Expanded Dhaka Water Supply Resilience Project

Corrigendum Notice-1

The following Corrigendum is hereby issued to the Bidding Documents for the "Construction of Primary and Secondary Distribution Mains of Padma Transmission Network including all Material Supplies with O&M Support within the Defect Notification Period at Dhaka South City Corporation Area (Package No.: W-1/ICB-02.01, Invitation Reference No:46.113.638.00.00.091.2026/ EDWSRP/ W-1/ ICB-02.01/IT-01; Date: 08 June 2026)" and shall form an integral part thereof at the respective references of the original bidding document.

Signature	Date
Drawn By		
Designed By		
Checked By		
Approved By		
		Drawing No. W-1/ICB-02.01.001
 Projection: Universal Transverse Mercator

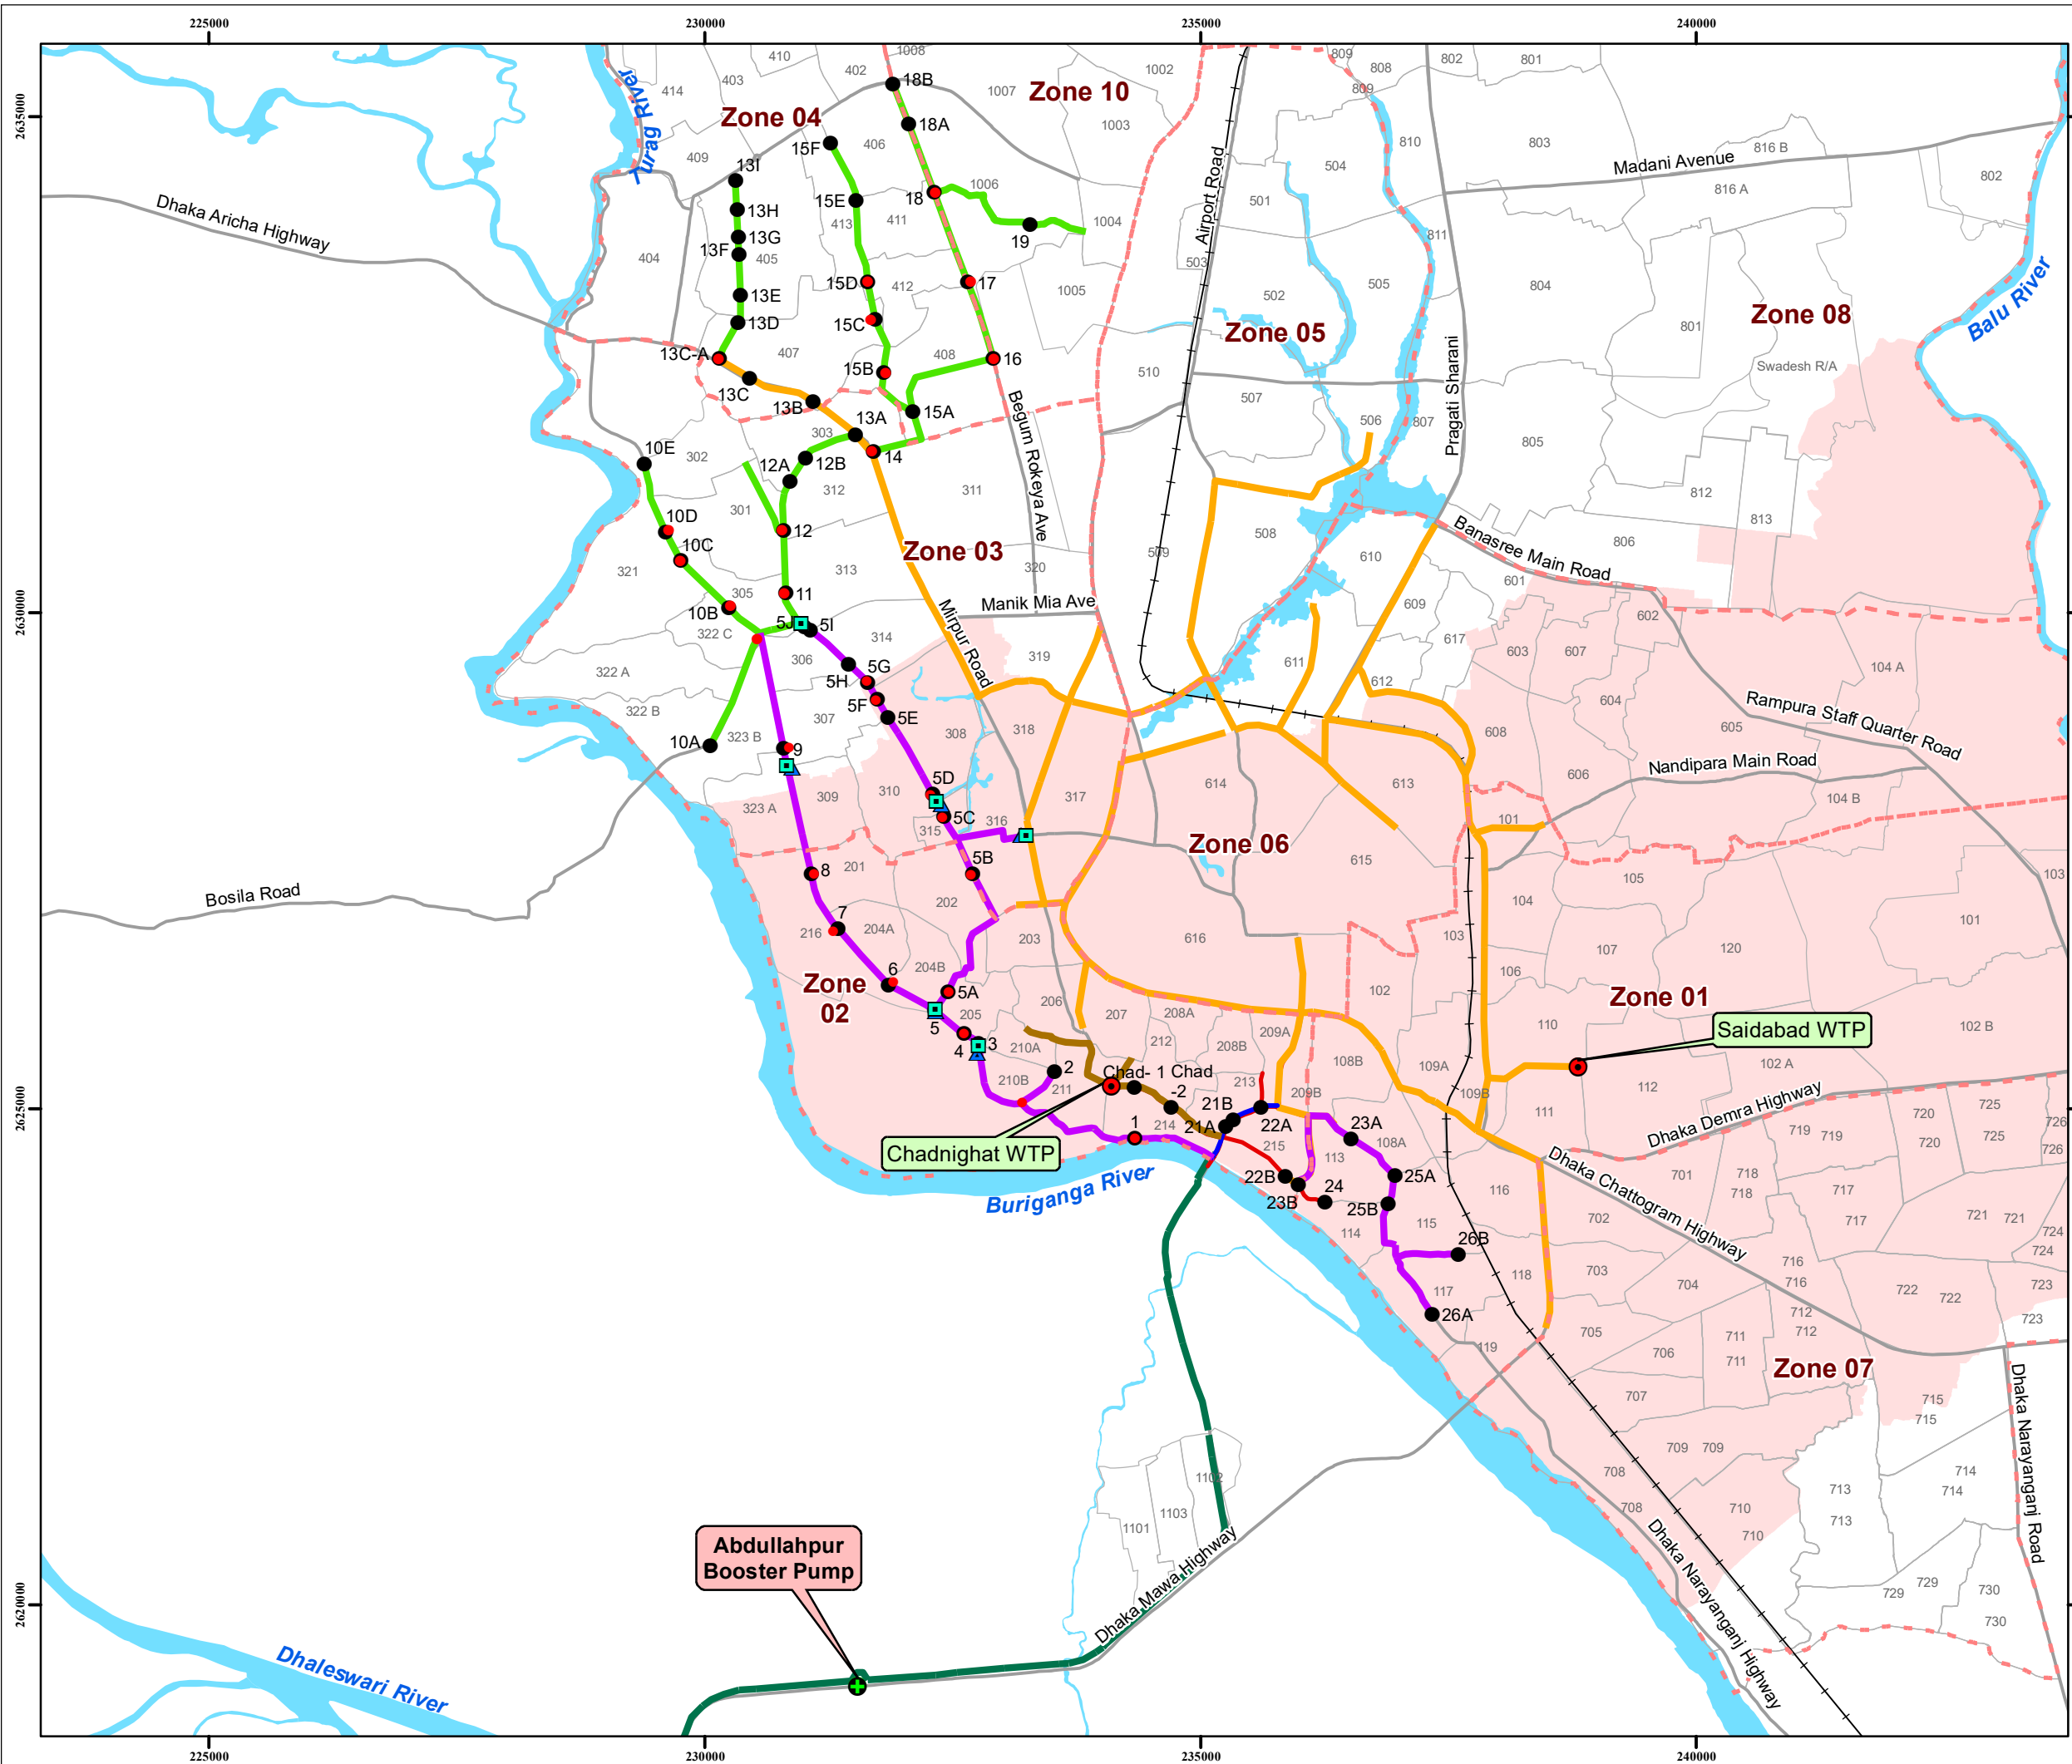
<u>Equipment Type and Characteristics</u>	<u>Type</u>														
Mobile Excavator	Owned														
Mobile dewatering pump	Owned														
<u>Equipment Type and Characteristics</u>	<u>Type</u>														
Mobile Excavator	Owned/Hired														
Mobile dewatering pump	Owned/Hired														
19	Volume 3 (Part IV) Outline Drawings and Maps Drawing No.: W-1/ICB-02.01.001, W-1/ICB-02.01.002, W-		Drawing Nos. W-1/ICB-02.01.001, W-1/ICB-02.01.002, W-1/ICB-02.01.003 and W1.IL.001 have been revised and are hereby replaced with the attached drawings.

Figure: 7-2 (a): Model Output Showing Velocity of Primary Distribution Network, Option 3

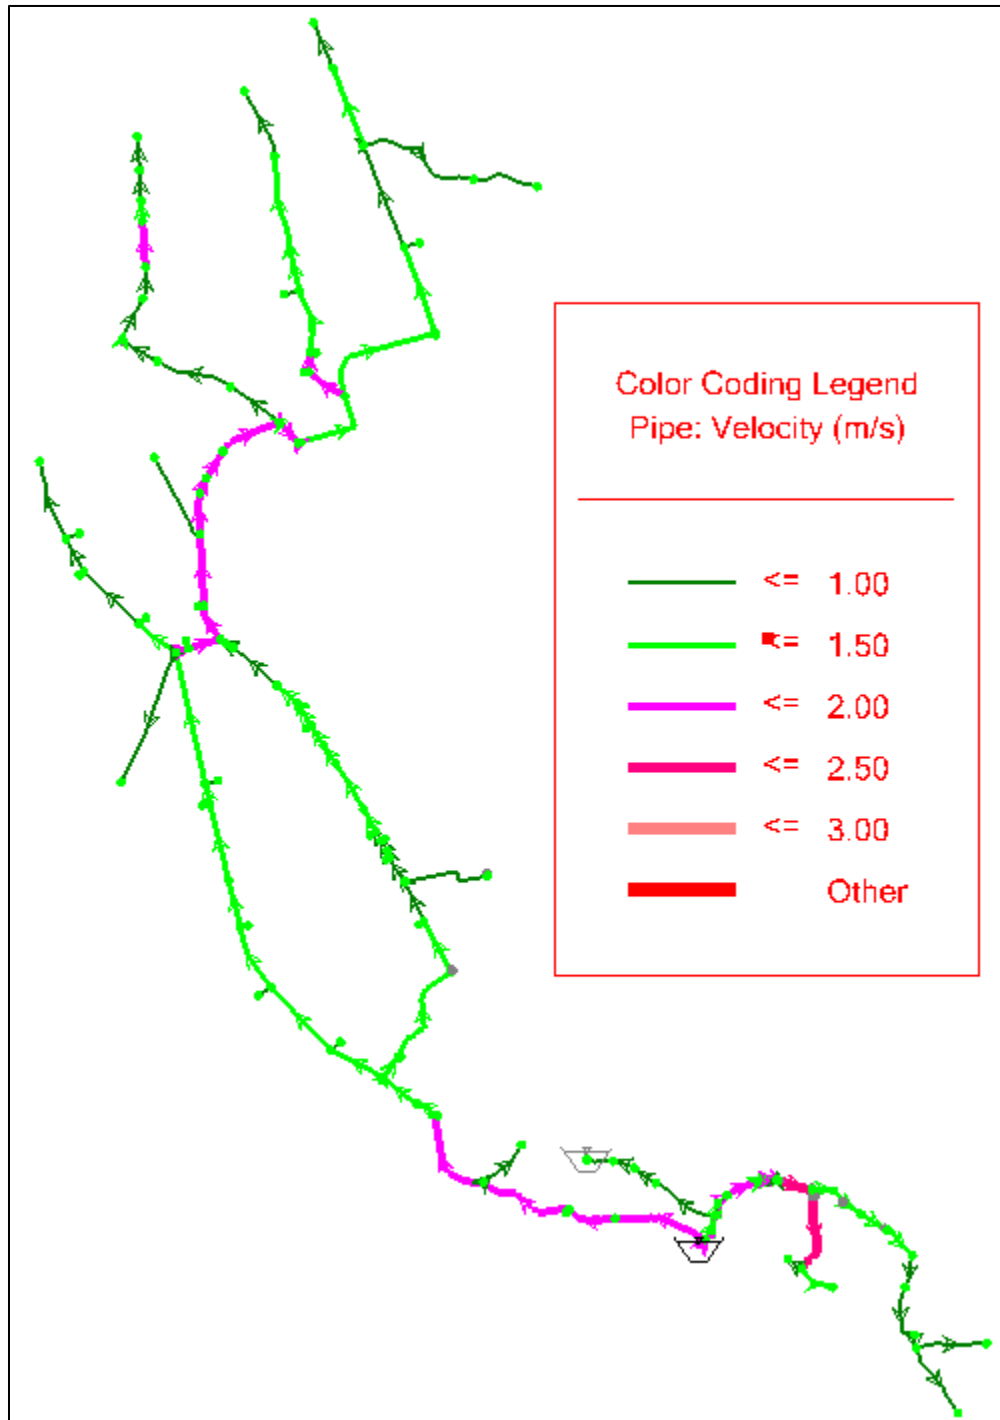
SL No.	Reference	Original	Corrigendum
	1/ICB-02.01.003, W1.IL.001		
20	Volume 3 (Part IV) Outline Drawings and Maps		The table showing the hydraulic model output in Volume 3, following Drawing No. W-1/ICB-02.01.GM13, has been replaced. Bidders shall refer to Table 7.2 (a) of Volume 4 (Part V) for the revised model output of Option 3.
21	Volume 3 (Part IV) Outline Drawings and Maps Drawing No.: W1.IL.003, W1.IL.004, W1.IL.005, W1.IL.014, W1.IL.015	Note: 4. The concrete wall will be C30 except lean concrete.	Note: 4. The concrete wall will be C35 except lean concrete.
22	Volume 3 (Part IV) Outline Drawings and Maps Drawing No.: W1.IL.011 Section A-A	Hauching to Frame Grade C30 Reinforced Concrete C30 Concrete Block C30	Haunching to Frame Grade C35 Reinforced Concrete C35 Concrete Block C35
23	Volume 4 (Part V) 7.2.5 Model Scenarios and Simulation		Added Figure 7-2 (a): Model output showing velocity of Primary Distribution Network, Option-3. Added Table 7.2 (a): Distribution and Connectivity Nodes of Padma Primary and Secondary Distribution Network, Option-3.
